UNITED STATES PATENT AND TRADEMARK OFFICE

Office Action Summary	Application No. 10/525,705	Applicant(s) MATHES ET AL.	
	Examiner ERNESTO GARCIA	Art Unit 3679

DETAILED ACTION

Attachment(s): one marked-up page of Cline, 2,083,054

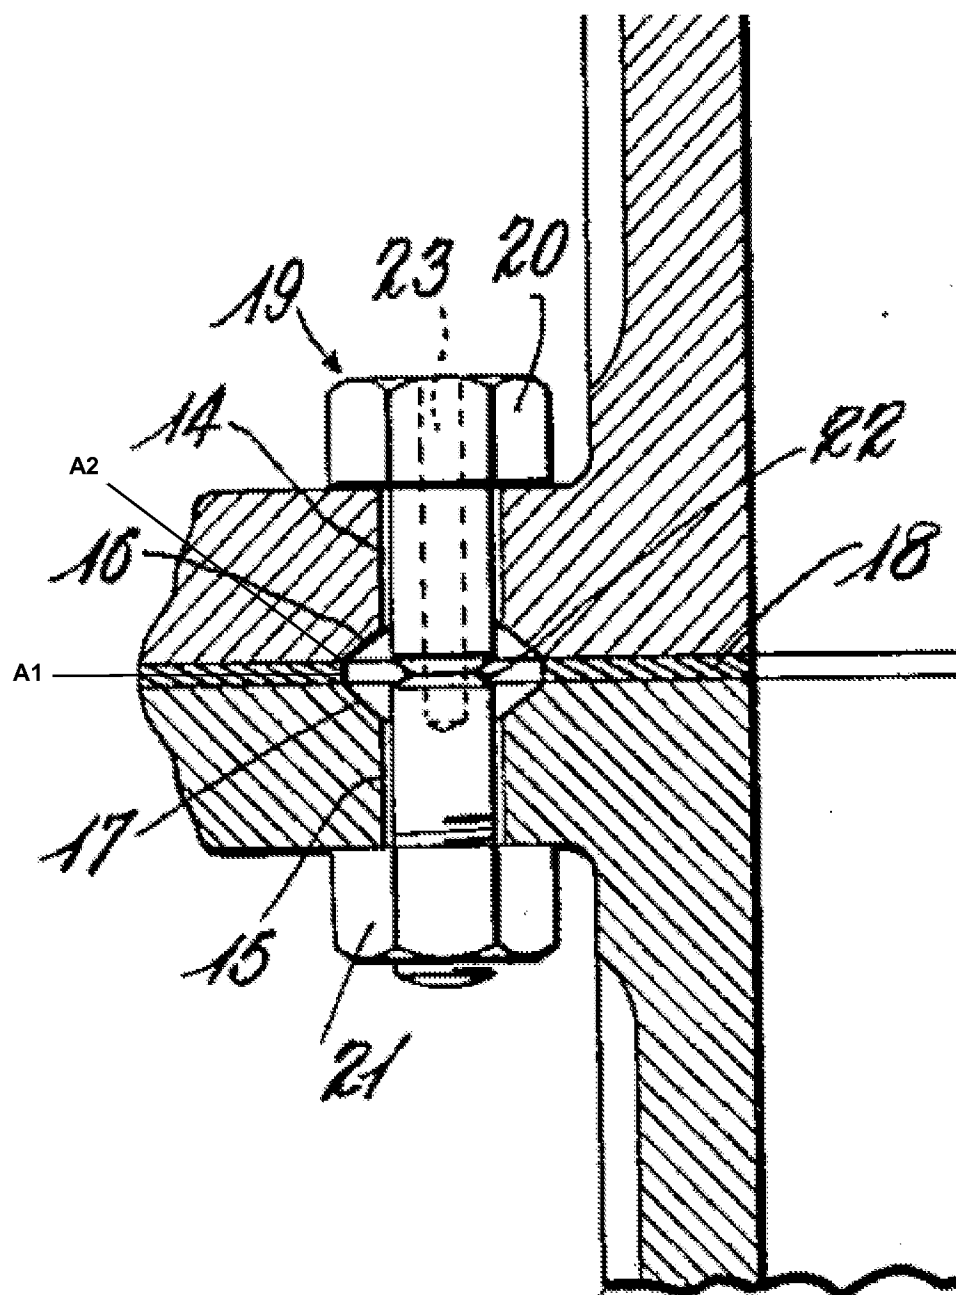
Regarding claim 11, Cline discloses, in Figure 1, a fastener system comprising a screw **19**, an annular flange **12**, and a stationary structure **18**. The screw **19** comprises a head **20** and a shank. The flange **12** comprises a through hole **14**. The through hole **14** comprises a distal segment (the cylindrical portion of the hole **14**), and a proximal segment **16**. The stationary structure **18** has a hole **A1** (see marked-up attachment). A cross-sectional area of the distal segment (the cylindrical portion of the hole **14**) taken in a direction perpendicular to a central axis of the through hole **14** is smaller than that of the proximal segment **16**. The proximal segment **16** provides a gap. The proximal segment **16** has an opening **A2** abutting the hole **A1** in the stationary structure **18** that is sized differently from a portion of the hole **A1** in the stationary structure **18** that abuts

the opening **A2** in the proximal segment **16** (note that the opening **A2** in the proximal segment is tapered and thus has different portions that are sized differently than that of the hole **A1** in the stationary structure).

Regarding claim 13, as best understood and assuming a portion of the shank is fully inserted in the through hole, Cline discloses a portion of the shank of the screw being fully inserted in the through hole. Further, a distance measured in a radial direction of the through hole between an inside wall of the proximal segment and an opposing outside surface of the screw shank is greater than a radius of the screw shank.
